OUTCOMES COMMITTEE

SUBJECT: Post Exhibition - Villawood Town Centre Development Control Plan 2020 - Amendment No.3
Premises: 1 Villawood Road Villawood (Lot:1 DP:1013056)
Applicant: DMPS (Daniel McNamara Planning Solutions)
Owner: ABA Holdings NSW Pty Ltd (Director/Secretary - Khaled Diab)
Zoning: E1 – Local Centre

Draft Amendment No.3

Figure 5. Vehicular Access and Car Parking in Villawood Town Centre

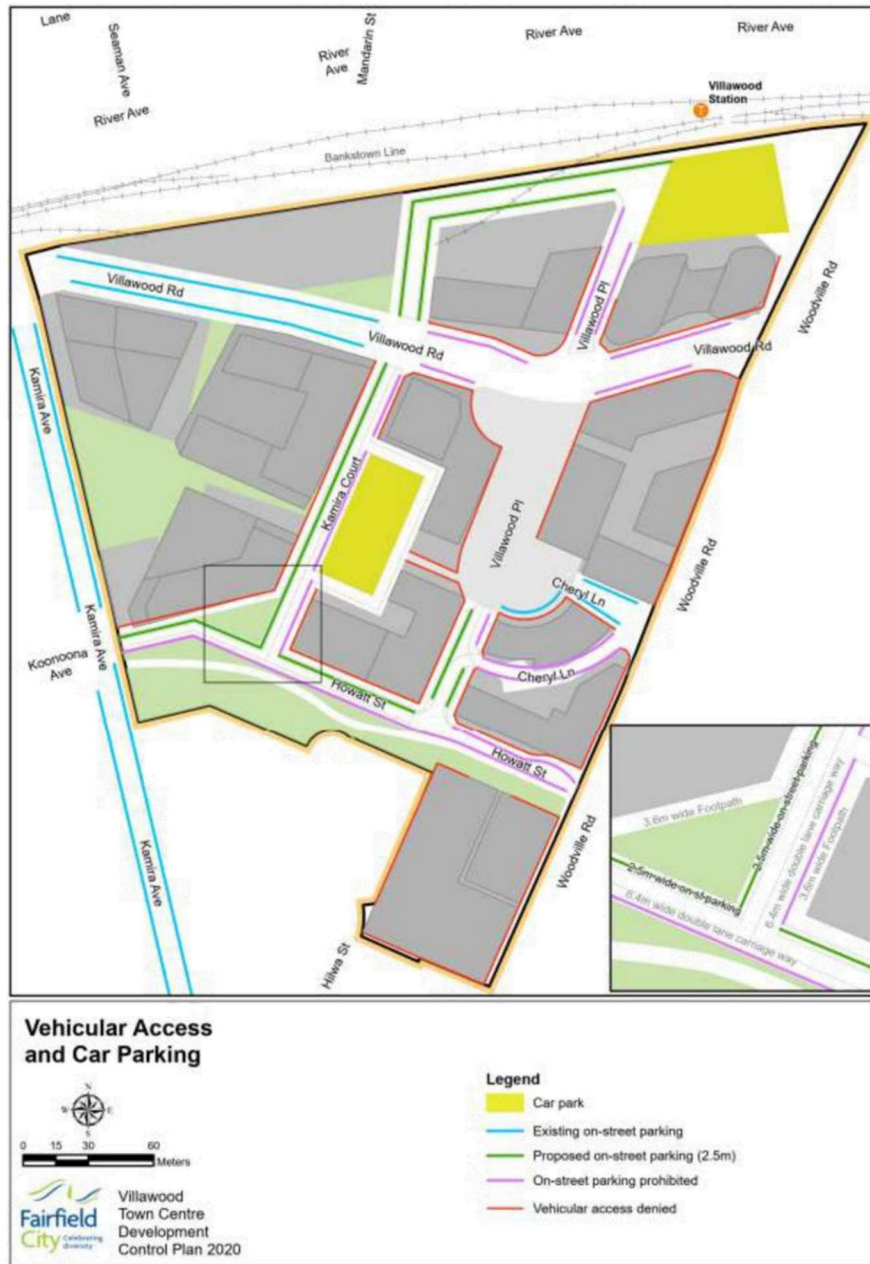
- Villawood Town Centre – Setbacks and number to storeys (Figure 4);
- Vehicular access and car parking in Villawood Town Centre (Figure 5); and
- Active street frontage and pedestrian connectivity in Villawood Town Centre (Figure 6).

The minor amendments will ensure the building forms within these maps are consistent with other figures and diagrams within the DCP.

10. Vehicular access must be consistent with Figure 5 below. Any significant redevelopment of 896-898 Woodville Road and 15 Hilwa Street (including construction of a basement level) must make provision for shared access to 896A Woodville Road via a suitable easement that allows for construction of a breakthrough basement connection at the first basement level. Access to 896A Woodville Road will not be permitted from Woodville Road.
